Consumers Power Company

January 23, 1970

Re: Docket 50-155  
DPR-6 ZEK

In an informational letter to you dated January 14, 1969, we informed you of our intention to install a control rod drive support structure in the Big Rock Point Nuclear Plant. The design and procurement of materials for the structure have progressed to the point that we now are planning to install it during the forthcoming Big Rock Point Plant refueling outage, scheduled for February 1970. It is the purpose of this letter to apprise you of the upcoming scheduled installation of the structure, to inform you of a design change and to discuss a few points concerning testing and surveillance raised by your staff.

# LOAD vs. DEFLECTION

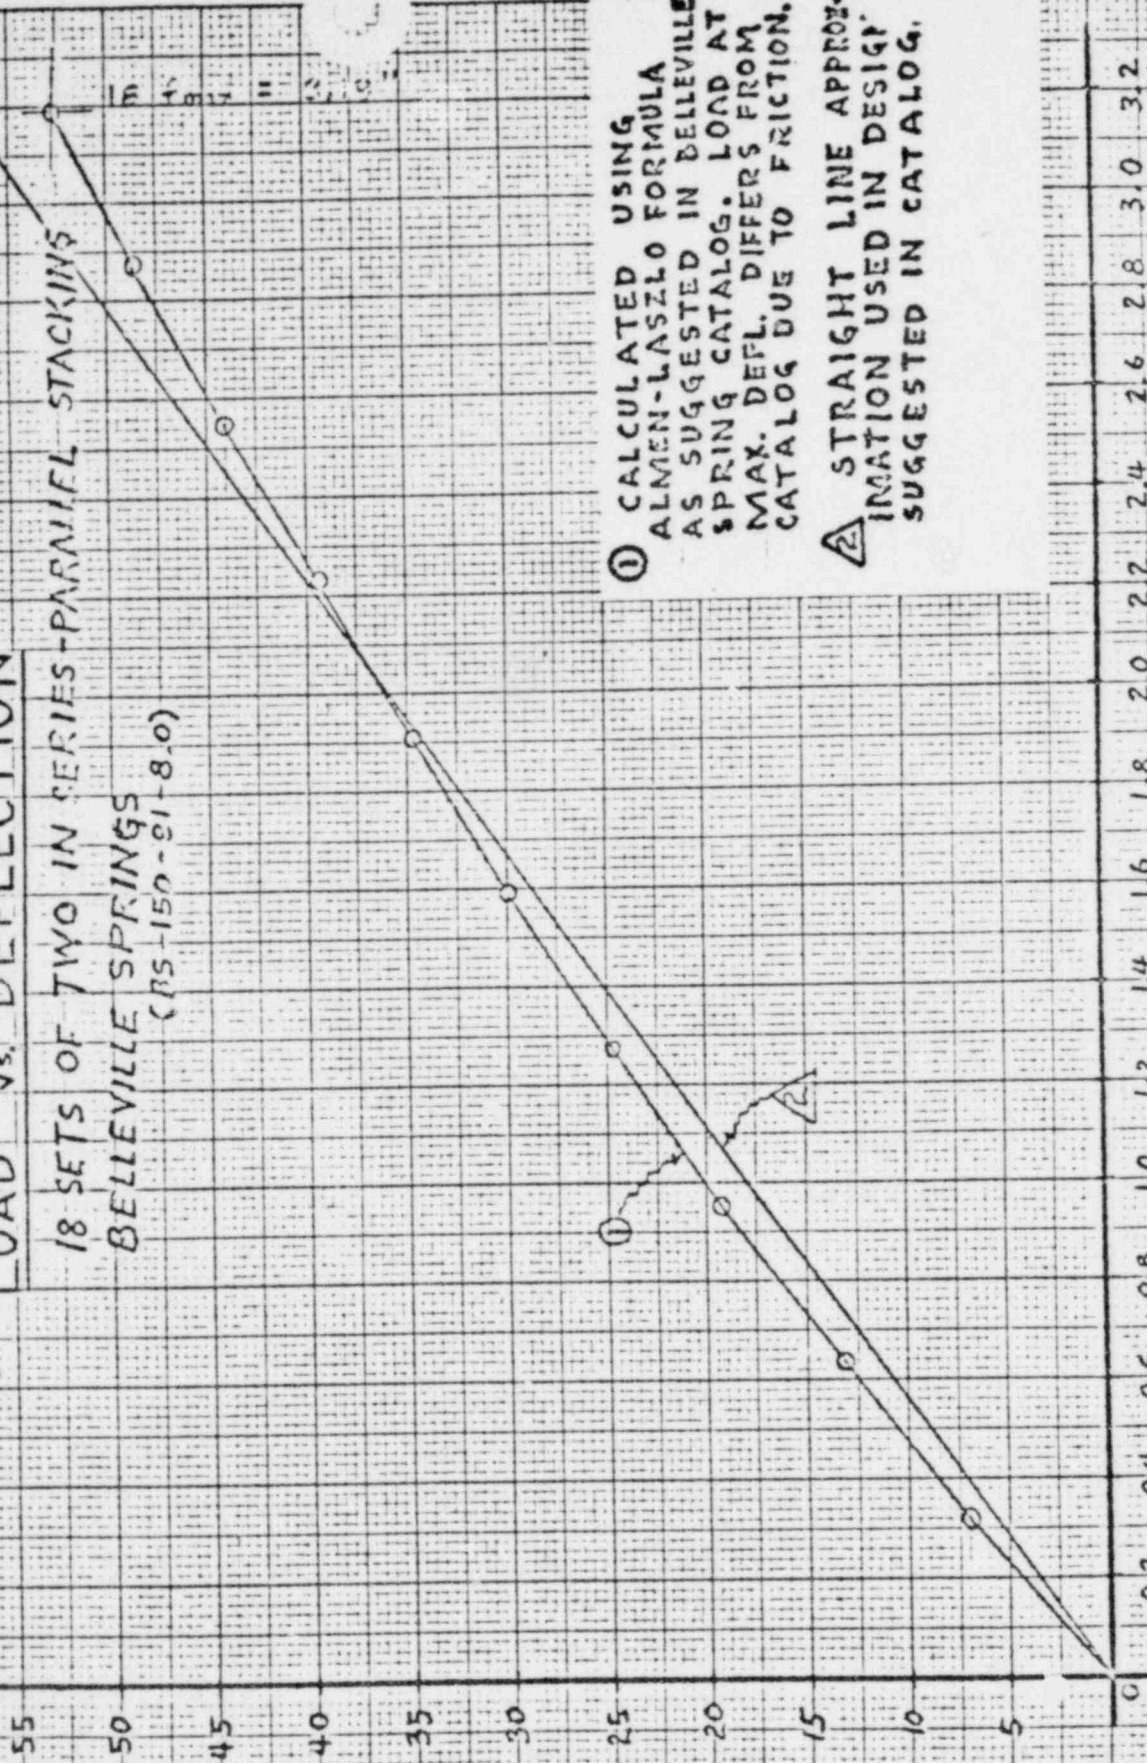
First, because of a design change involving the characteristics of the Belleville washers, the original load-deflection calculations were redone. This necessitated a change in our original letter. On Page 4, Line 11 of the first paragraph of Stress Analysis, starting with the word "Considering," the remainder of the paragraph should read, with changes underlined:

"Considering that the control rod drive housing will travel about 0.26 inches downward before encountering the resisting support assembly, and, also considering that the support assembly will offer a resistance at each corner column of 18,100 lbs. per inch of downward travel, calculations reveal that a downward travel of 2.84 inches at the corner column will result for the case where the failed assembly is nearest that corner column. With a corresponding dynamic load factor of 2.25, this will result in a maximum dynamic load of 88.2 kips and a total downward movement of 2.37 inches for the control rod at the location of the control rod. For the case where the failed assembly is near the center of the support grid, the deflection will be 1.30 inches under the failed assembly and at each corner column, and a total downward movement of 1.56 inches for the control rod. With

a corresponding dynamic load factor of 2.41, this will result in a maximum dynamic load of 94.5 kips at the location of the control rod."

Attached is a load-deflection curve for the Belleville washer shock absorber assembly.
